HISTORIC AND DESIGN REVIEW COMMISSION

Agenda Item No: 13

HDRC CASE NO: 2015-096
ADDRESS: 821 N PINE ST
LEGAL DESCRIPTION: NCB 540 BLK 11 LOT C & D ARB A4 & A5
ZONING: R5 H
CITY COUNCIL DIST.: 2
DISTRICT: Dignowity Hill Historic District
APPLICANT: Porter Dillard/Dillard Architect Group
OWNER: Tony Gradney
TYPE OF WORK: Window replacement

Gradney Residence – Historical House Restoration – Dignowity Hill
821 N. Pine St., San Antonio, Texas
Architect’s Project No. 2013-05

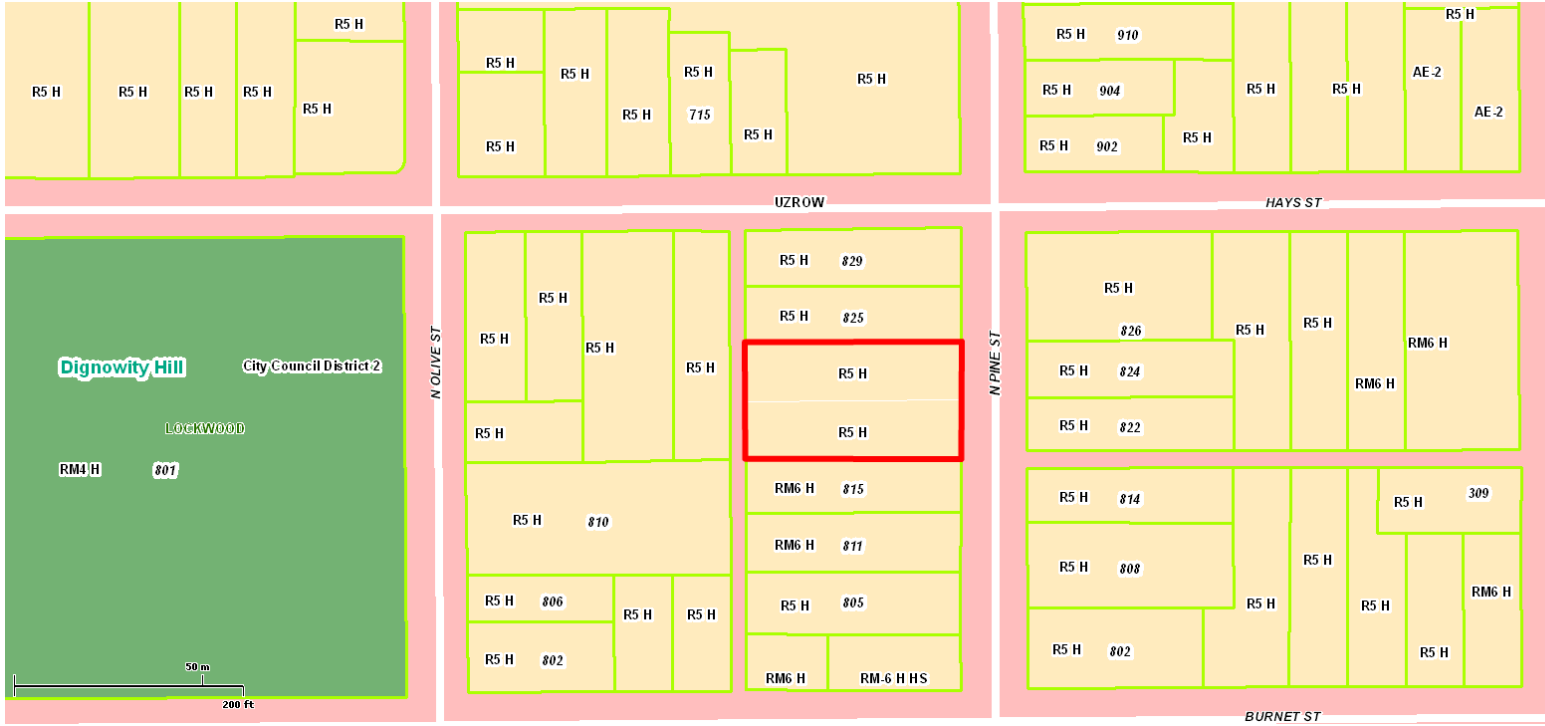
- c. Pictures provided by the applicant in 2014, show that some original wood windows remained in place after demolition of fire damaged areas was completed. Consistent with the Guidelines for Exterior Maintenance and Alterations, historic windows should be preserved. If deteriorated beyond repair, they should be replaced in kind to match existing in terms of size, type, configuration, material, form, appearance, and detail. Although the proposed windows will match the

historic windows in terms of size and configuration, the proposed fibrex material which is a composite of wood fibers and vinyl is not consistent with the guidelines and is not an appropriate replacement for wood windows. In areas where the original windows were lost due to fire, the proposed new windows may be an appropriate replacement and would provide a clear distinction between the original and the new areas of the house.

Staff does not recommend approval as submitted based on findings a-c. Staff recommends that all original windows remaining after the fire that are deteriorated beyond repair are replaced with wood windows to match existing and that only windows that were lost in the fire are replaced with the proposed material.

Proposed window schedule

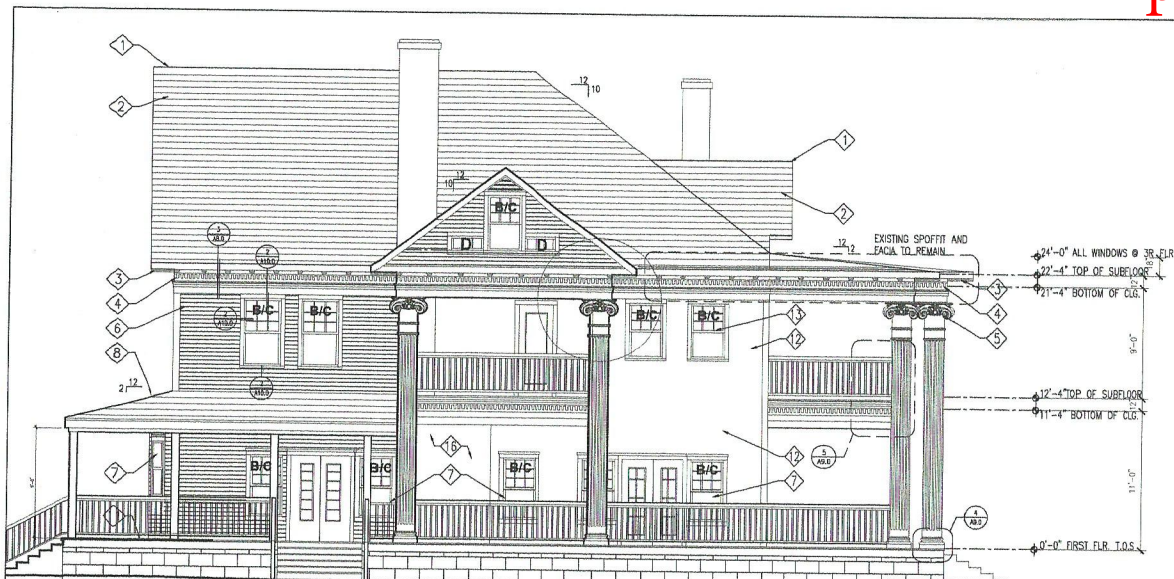
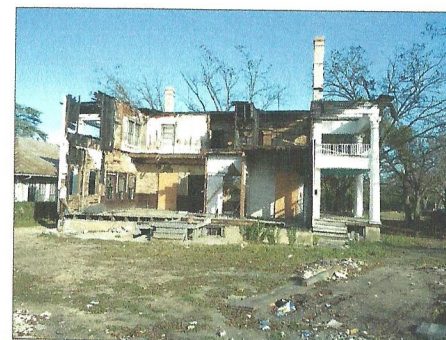
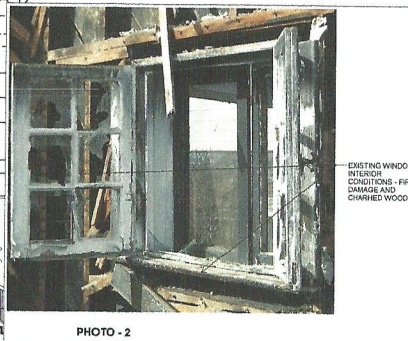
- A ORIGINAL SH WOOD WINDOW
- B NEW SH VINYL WINDOW FRAME MGF STANDARD SIZE
- C NEW SH COMPOSITE (WOOD AND VINYL) WINDOW MGF STANDARD SIZE (MGF ANDERSON - FIBREX)
- D FIXED GLASS IN VINYL FRAME OR COMPOSITE FRAME (WOOD AND VINYL ANDERSON - FIBREX FRAME)

NOTE: SPECIAL CONSIDERATIONS FOR ALL WINDOWS TO BE VINYL FRAMES EXCLUDING WINDOW "A" (WINDOW "A" TO REMAIN EXISTING WOOD WINDOW)

Sheet Name
EAST & NORTH ELEVATIONS

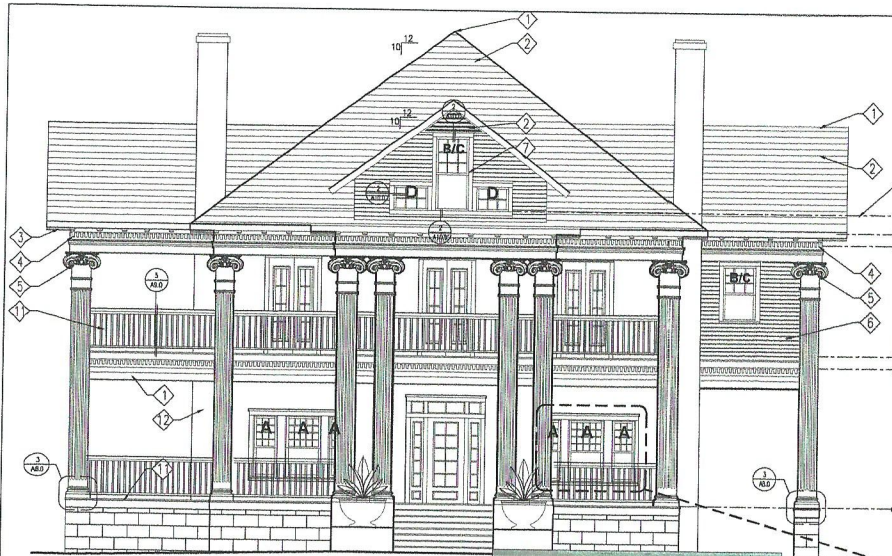
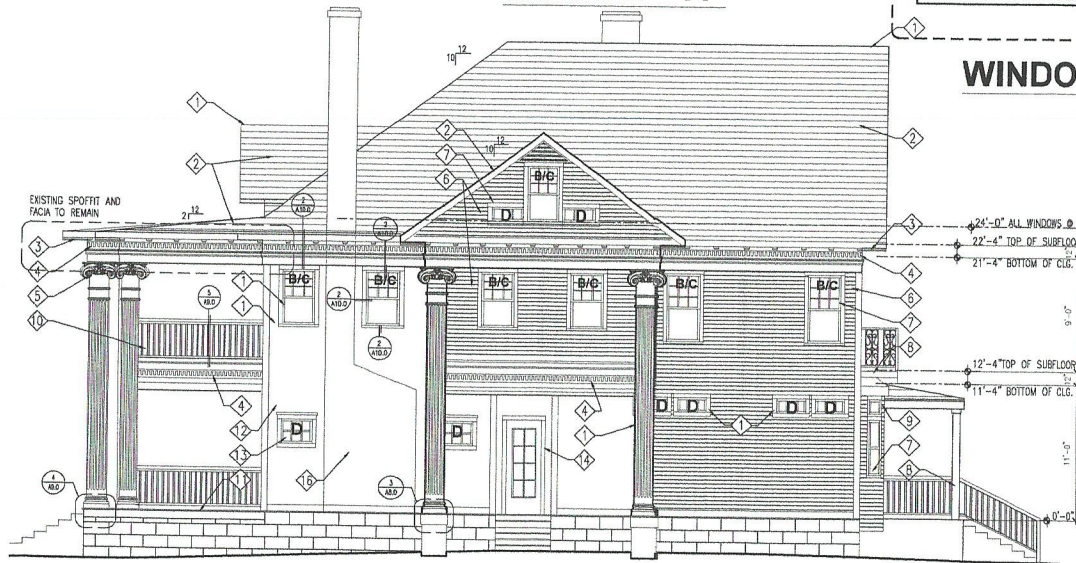
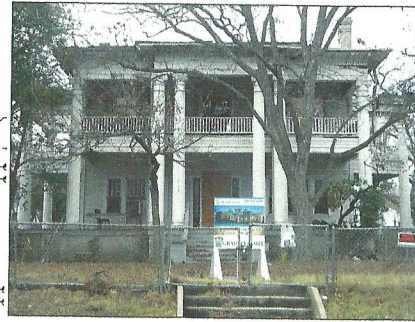
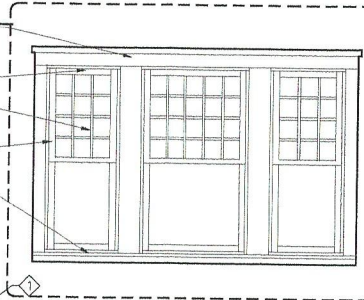
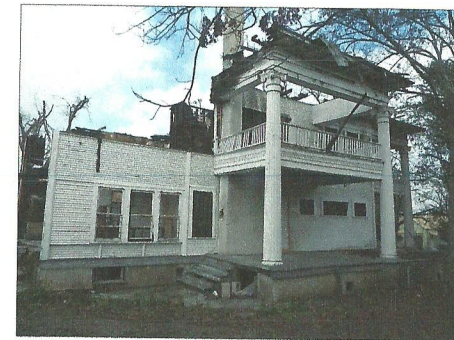
- A ORIGINAL SH WOOD WINDOW
- B NEW SH VINYL WINDOW FRAME MGF STANDARD SIZE
- C NEW SH COMPOSITE (WOOD AND VINYL) WINDOW MGF STANDARD SIZE (MGF ANDERSON - FIBREX)
- D FIXED GLASS IN VINYL FRAME OR COMPOSITE FRAME (WOOD AND VINYL ANDERSON - FIBREX FRAME)

NOTE: SPECIAL CONSIDERATIONS FOR ALL WINDOWS TO BE VINYL FRAMES EXCLUDING WINDOW "A" (WINDOW "A" TO REMAIN EXISTING WOOD WINDOW)
